3GPP TSG-RAN WG2 Meeting #31 ***R2-022345***
Stockhom, Sweden, 19-23 August 2002

⌘ **25.302** **CR** **129** ⌘ **rev** **1** ⌘ Current version: **3.13.0** ⌘

Title:	⌘	Correction of transport to physical channel mapping for TDD
Source:	⌘	Nortel Networks
Work item code:	⌘	TEI
Date:	⌘	13/08/2002
Category:	⌘	**F**
Release:	⌘	R99

Figure 4: Model of the UE's physical layer – downlink TDD mode

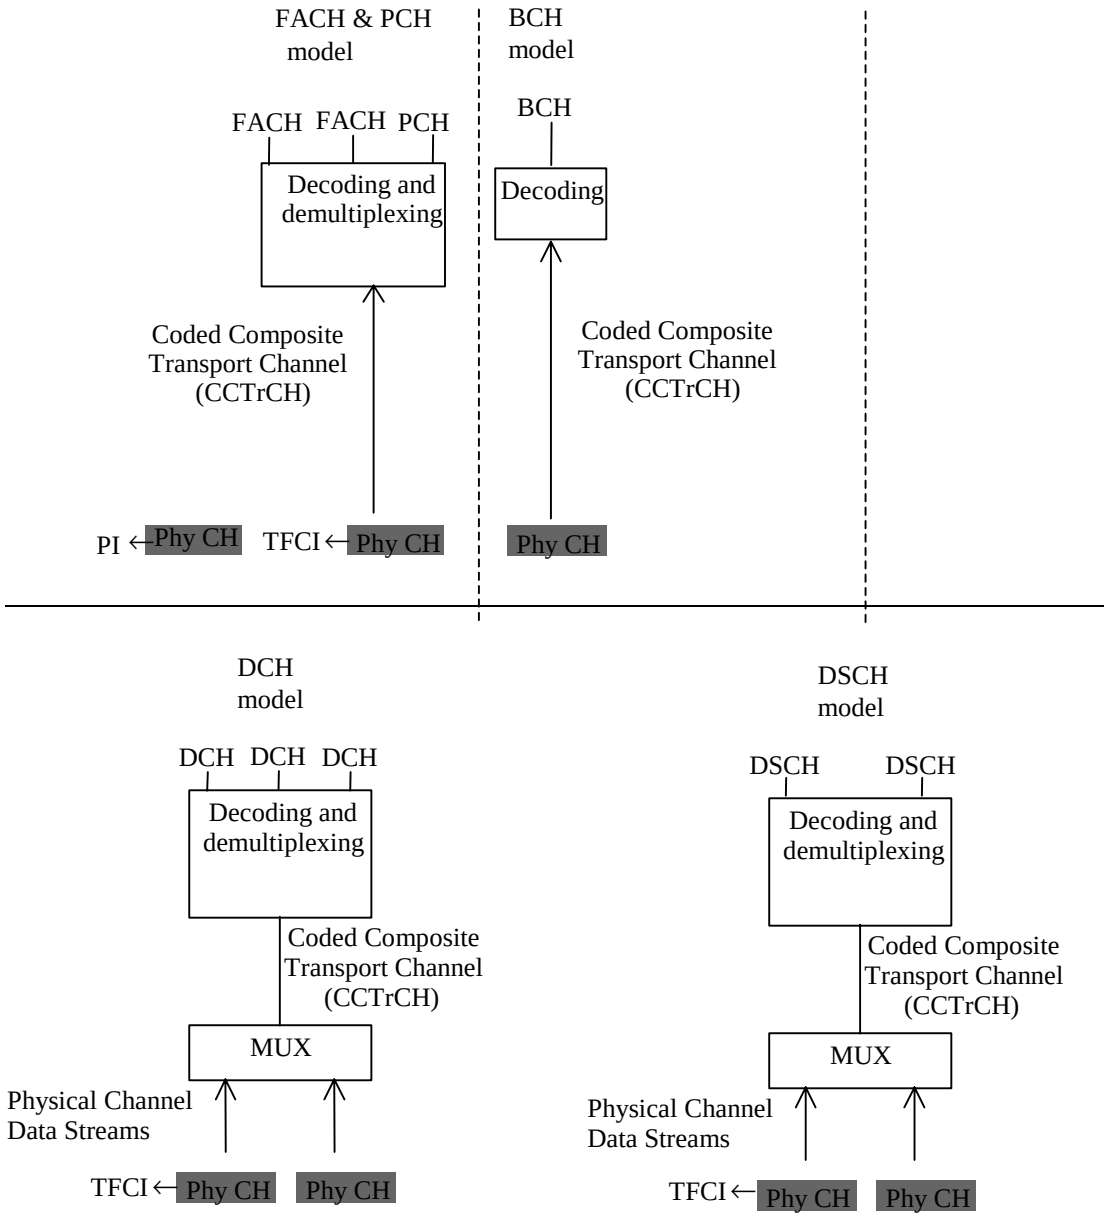
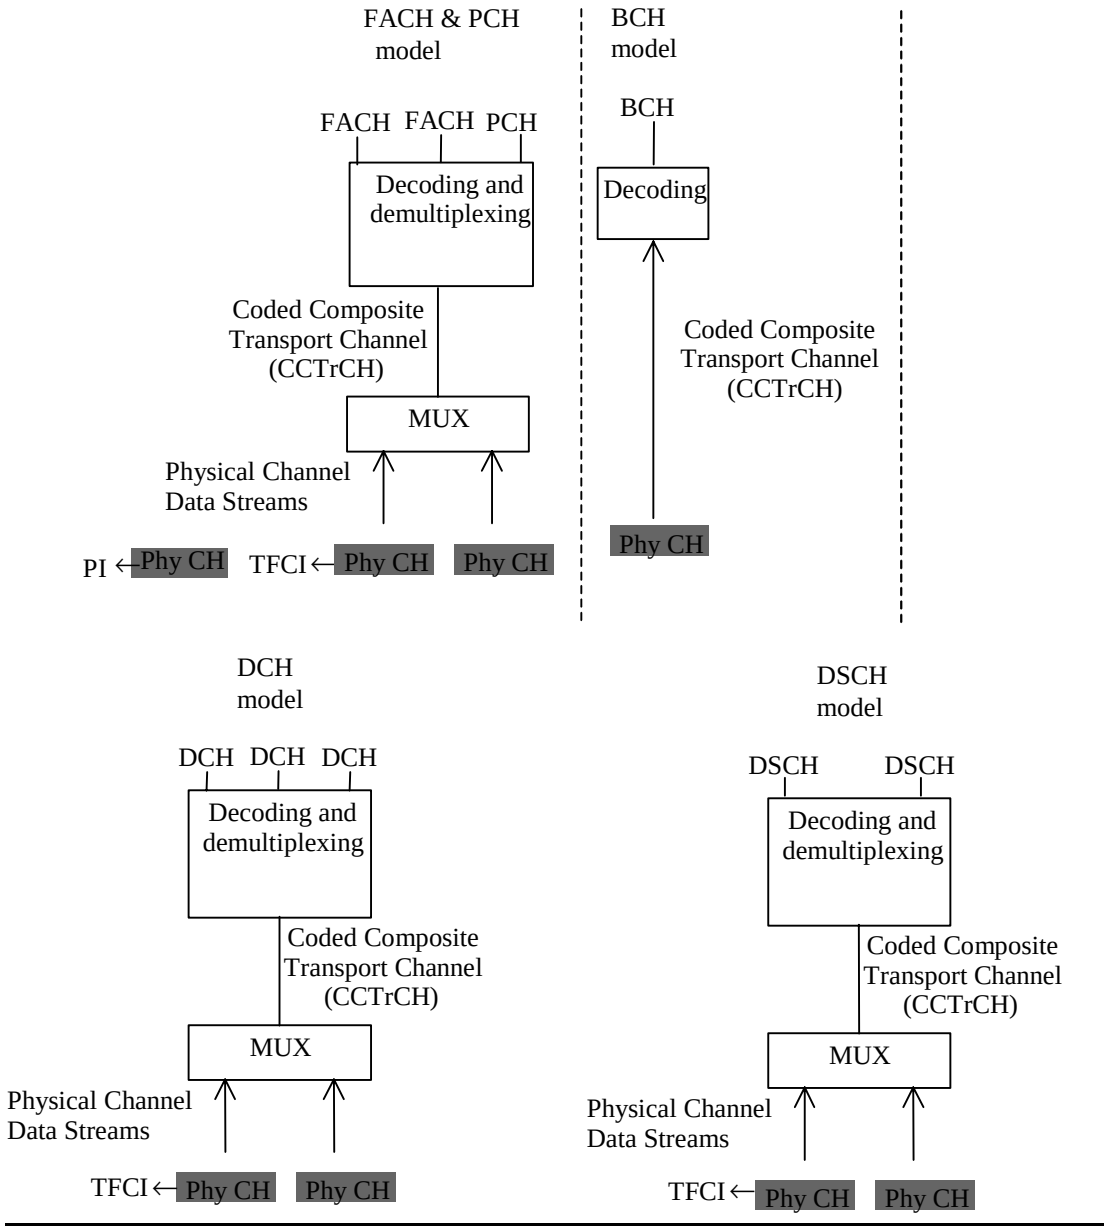
Reason for change:	⌘	The diagram shown in section 6.2 indicates that for TDD it is only possible to map FACH/PCH transport channels onto a single physical channel. However CCTrCh carrying FACH/PCH can be multiplexed over a number of physical channels if required in TDD.
Summary of change:	⌘	The diagram in section 6.2 is changed so that a CCTrCh carrying FACH/PCH can be multiplexed over several physical channel data streams. Also an additional paragraph is added to clarify that in TDD is possible to multiplex FACH/PCH CCTrCh over several physical channels.
Consequences if not approved:	⌘	A UE implementing the current model would not support certain multiplexing schemes for common channels e.g. paging channel, hence forbidding these shemes from operators since these channels are sent to all UEs. **Impact analysis:** This CR is considered to have isolated impact since it only affects TDD mode. The CR is for clarification only but it contains a fundamental issue in TDD mode.

Note that in the TDD mode a CCTrCh carrying PCH and one or several FACH can be multiplexed onto one or several physical channel data streams.

Figure 4: Model of the UE's physical layer – downlink TDD mode

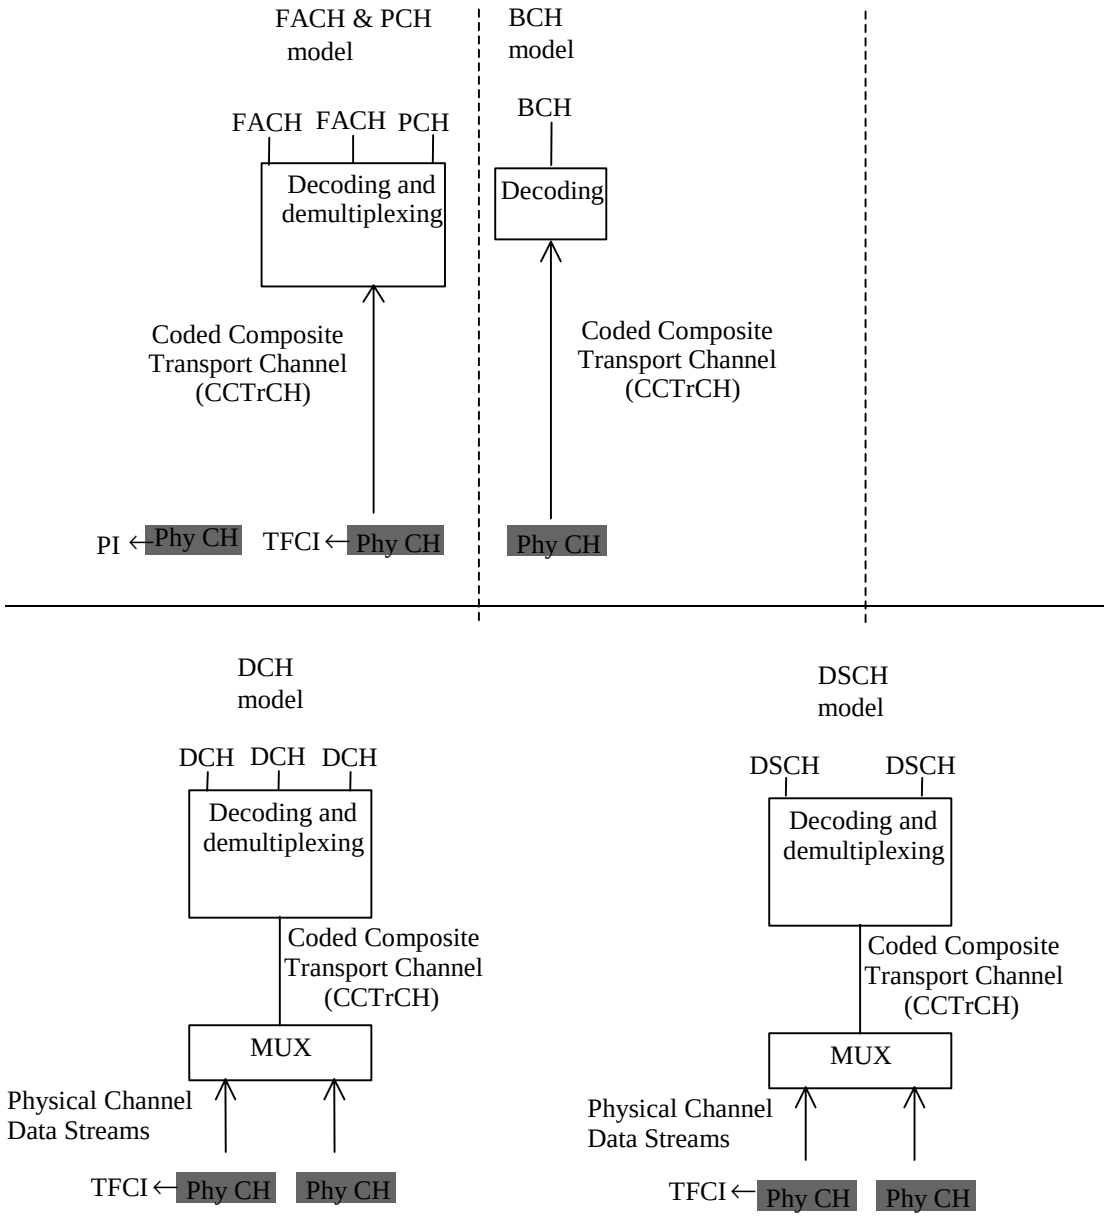
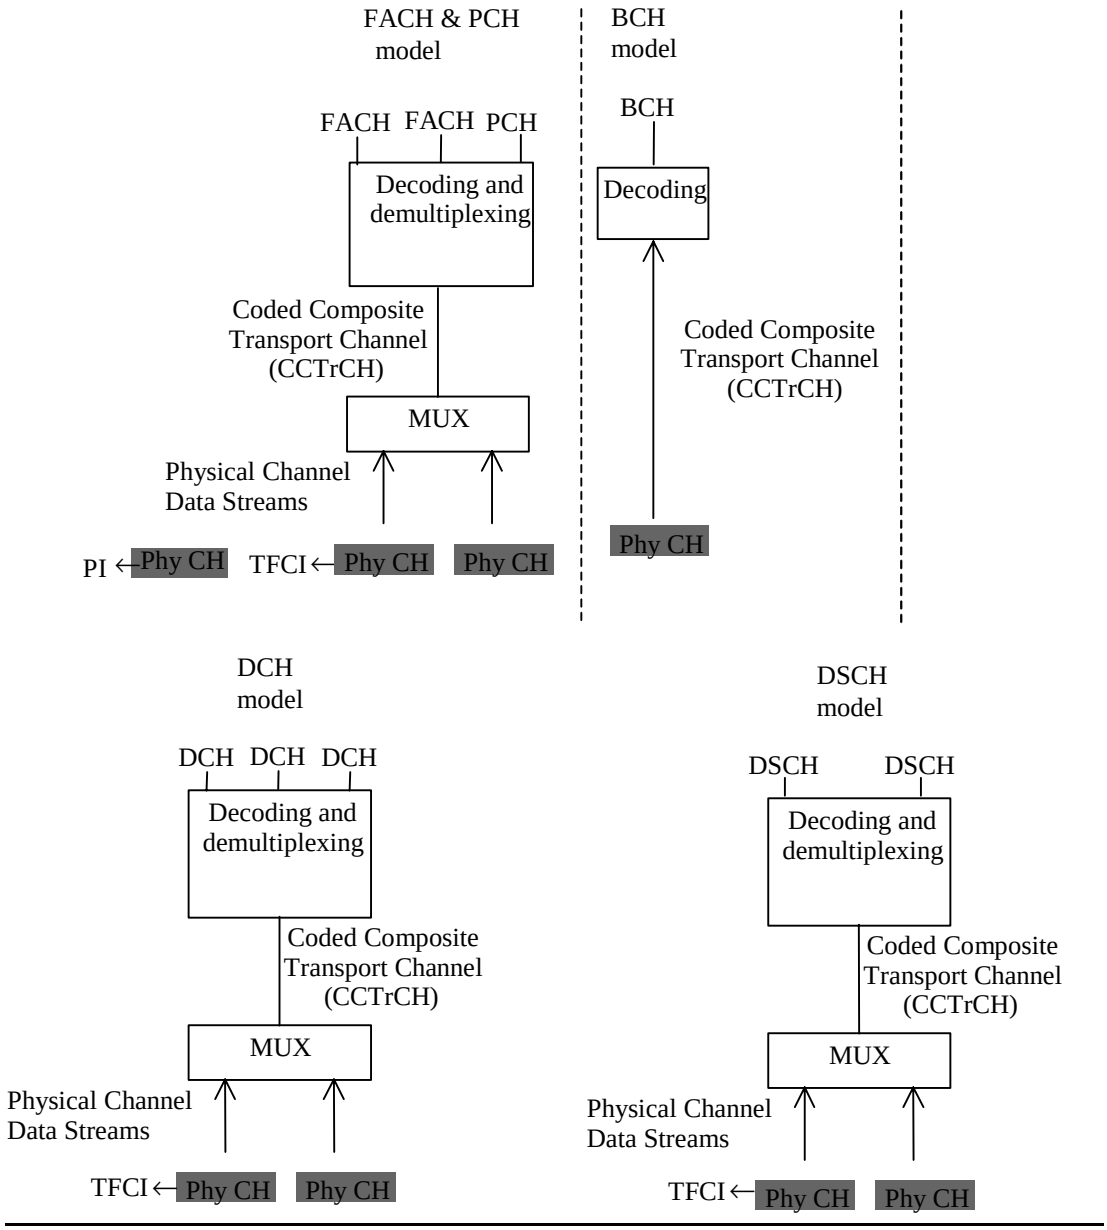
Reason for change:	⌘	The diagram shown in section 6.2 indicates that for TDD it is only possible to map FACH/PCH transport channels onto a single physical channel. However CCTrCh carrying FACH/PCH can be multiplexed over a number of physical channels if required in TDD.
Summary of change:	⌘	The diagram in section 6.2 is changed so that a CCTrCh carrying FACH/PCH can be multiplexed over several physical channel data streams. Also an additional paragraph is added to clarify that in TDD is possible to multiplex FACH/PCH CCTrCh over several physical channels.
Consequences if not approved:	⌘	A UE implementing the current model would not support certain multiplexing schemes for common channels e.g. paging channel, hence forbidding these shemes from operators since these channels are sent to all UEs. **Impact analysis:** This CR is considered to have isolated impact since it only affects TDD mode. The CR is for clarification only but it contains a fundamental issue in TDD mode.

Note that in the TDD mode a CCTrCh carrying PCH and one or several FACH can be multiplexed onto one or several physical channel data streams.

Figure 4: Model of the UE's physical layer – downlink TDD mode

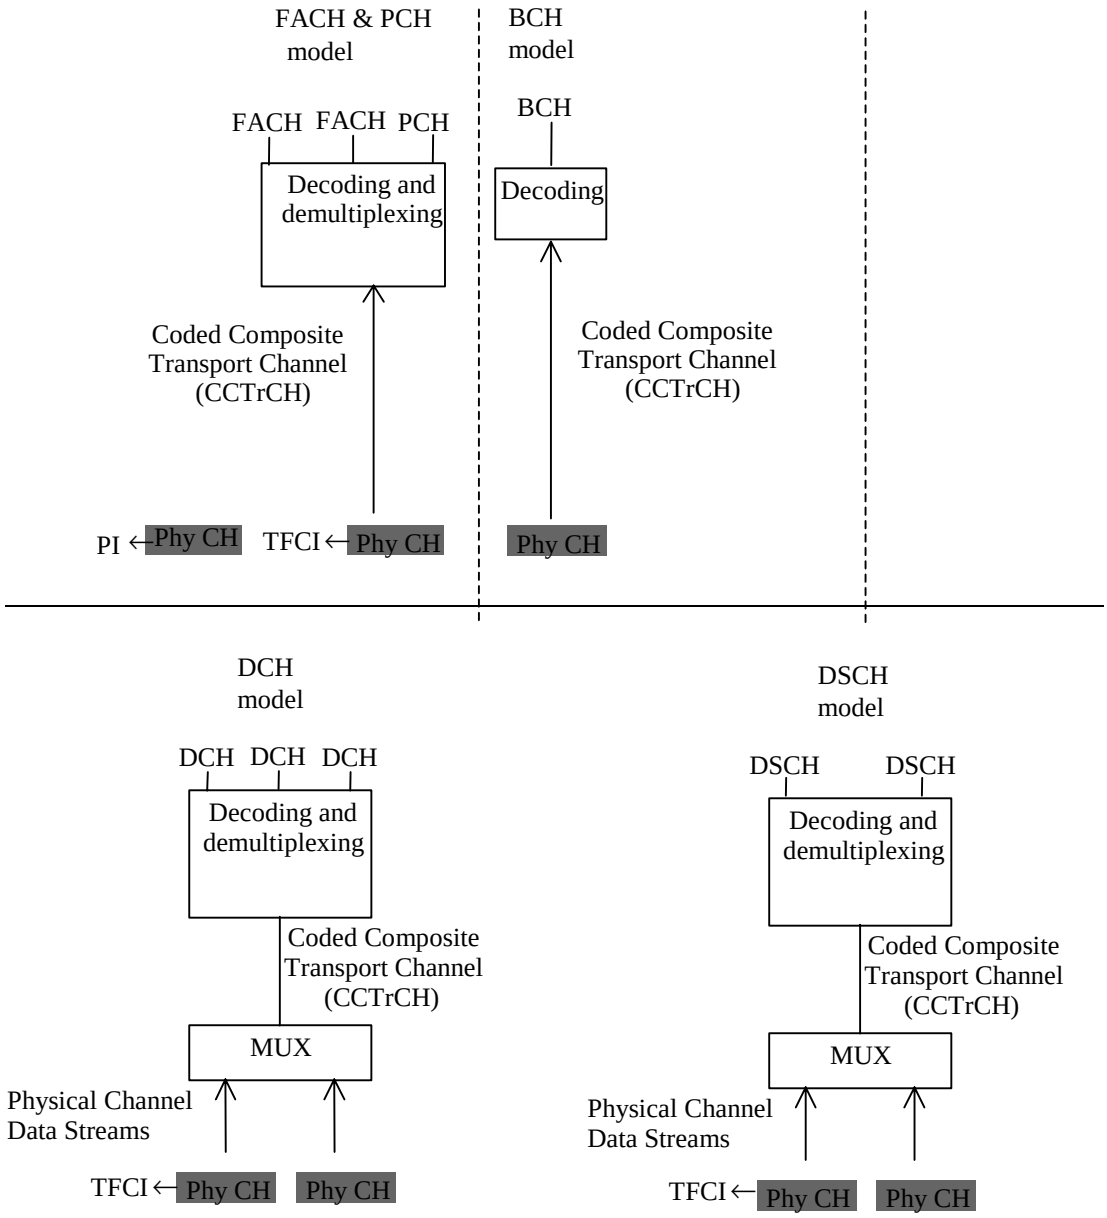
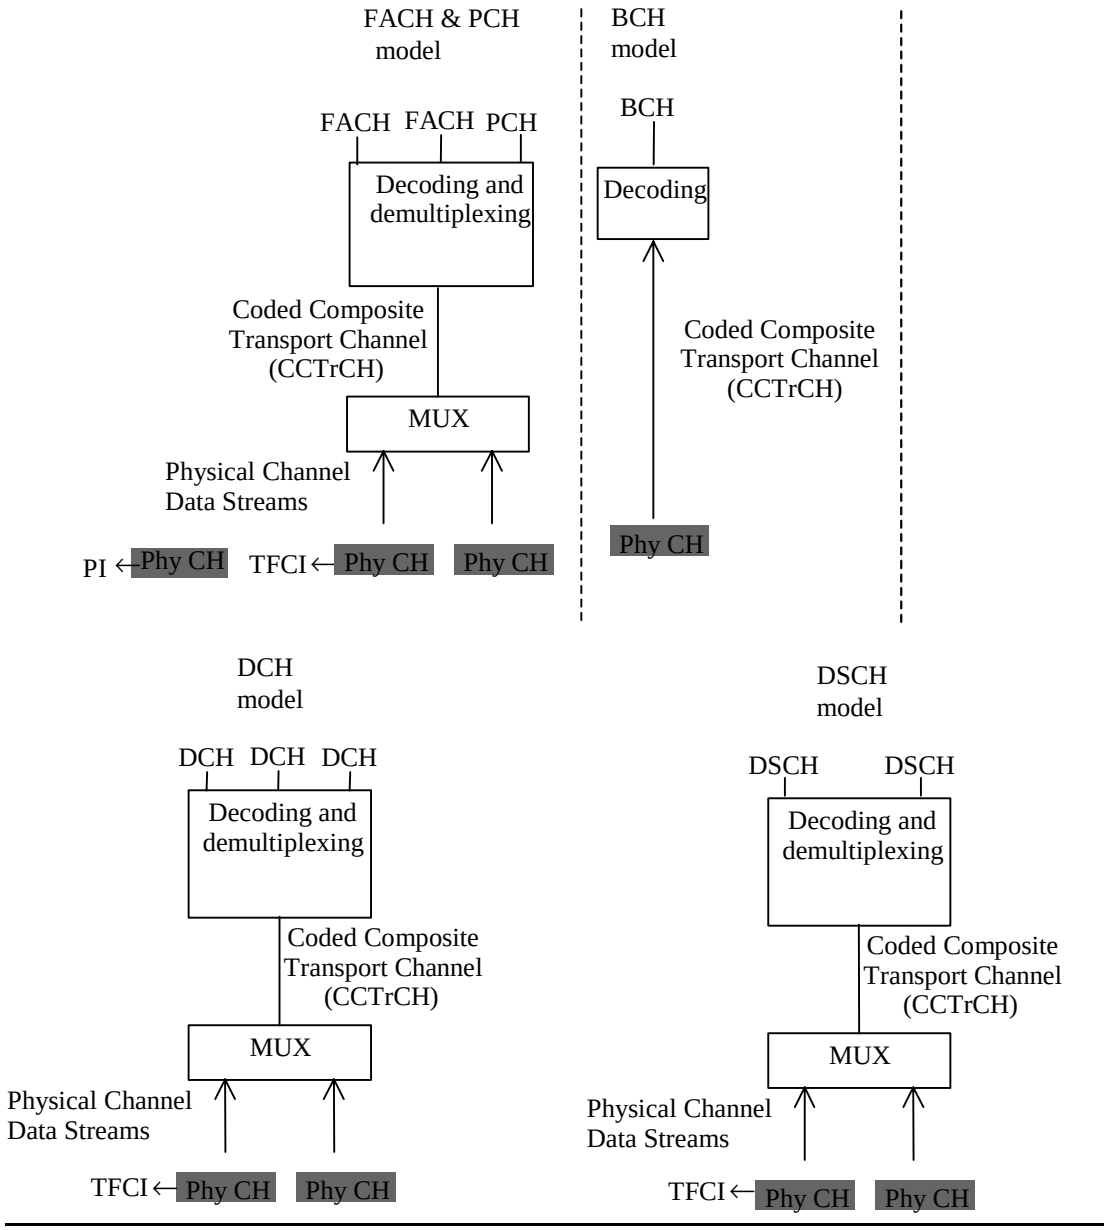
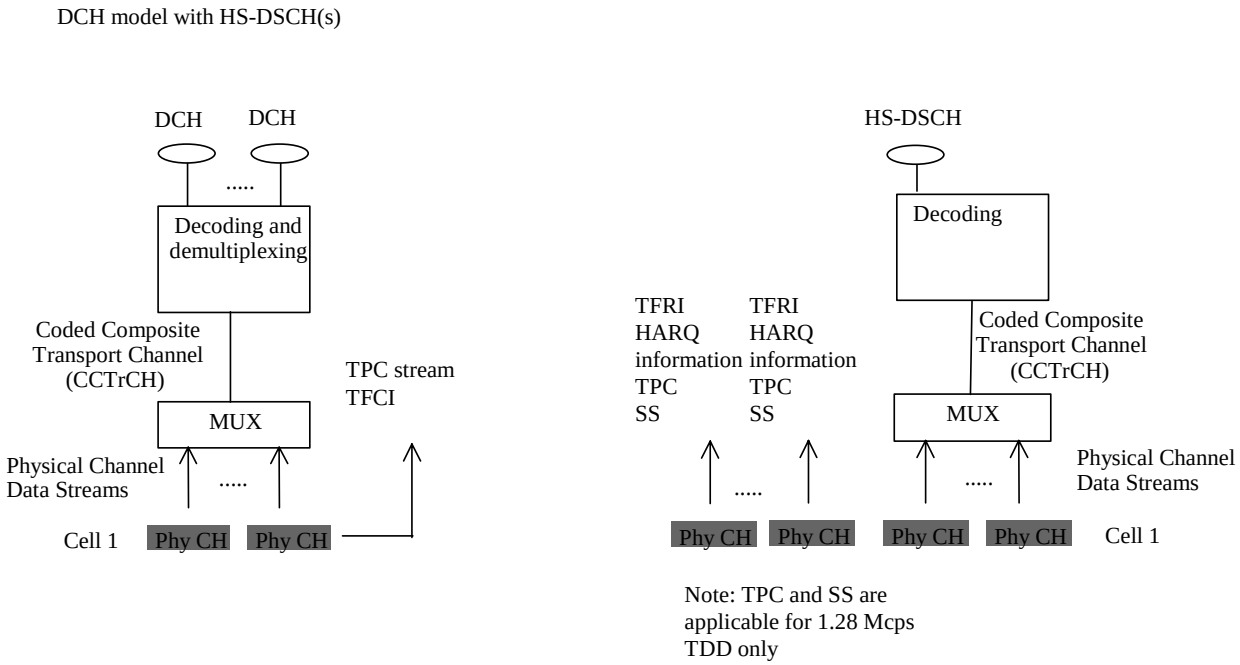
Reason for change:	⌘	The diagram shown in section 6.2 indicates that for TDD it is only possible to map FACH/PCH transport channels onto a single physical channel. However CCTrCh carrying FACH/PCH can be multiplexed over a number of physical channels if required in TDD.
Summary of change:	⌘	The diagram in section 6.2 is changed so that a CCTrCh carrying FACH/PCH can be multiplexed over several physical channel data streams. Also an additional paragraph is added to clarify that in TDD is possible to multiplex FACH/PCH CCTrCh over several physical channels.
Consequences if not approved:	⌘	A UE implementing the current model would not support certain multiplexing schemes for common channels e.g. paging channel, hence forbidding these shemes from operators since these channels are sent to all UEs. **Impact analysis:** This CR is considered to have isolated impact since it only affects TDD mode. The CR is for clarification only but it contains a fundamental issue in TDD mode.

Note that in the TDD mode a CCTrCh carrying PCH and one or several FACH can be multiplexed onto one or several physical channel data streams.
